environmental statement

OYSTER CREEK NUCLEAR GENERATING STATION

DOCKET NO. 50-219

DECEMBER 1974

FIGURE 11.1 OYSTER CREEK THERMAL FIELD
 (Based on Data of July 13, 1973)

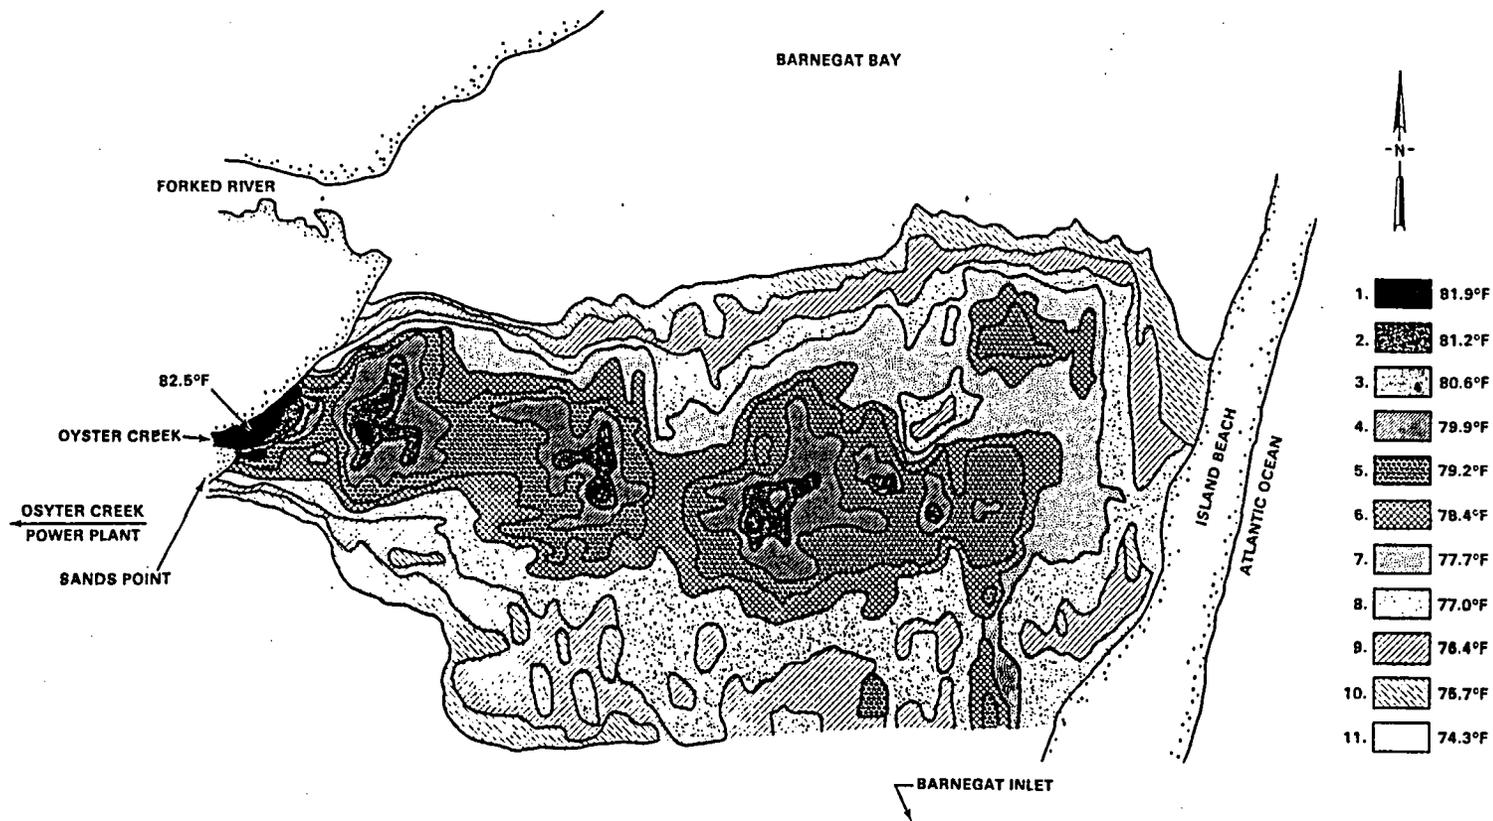
Response: Recent data show that the plant discharge produces a thermal field extending over the full width of the bay and imposing a temperature differential of more than 1.5°F over ambient water temperatures. The thermal plume on July 13, 1973, when the data were taken, extended from the mouth of Oyster Creek to Island Beach, as shown in Figure 11.1. The projection extended essentially eastward. Conceivably patterns proceeding northeasterly or southeasterly could occur, depending upon current direction, although there are no additional supporting data.
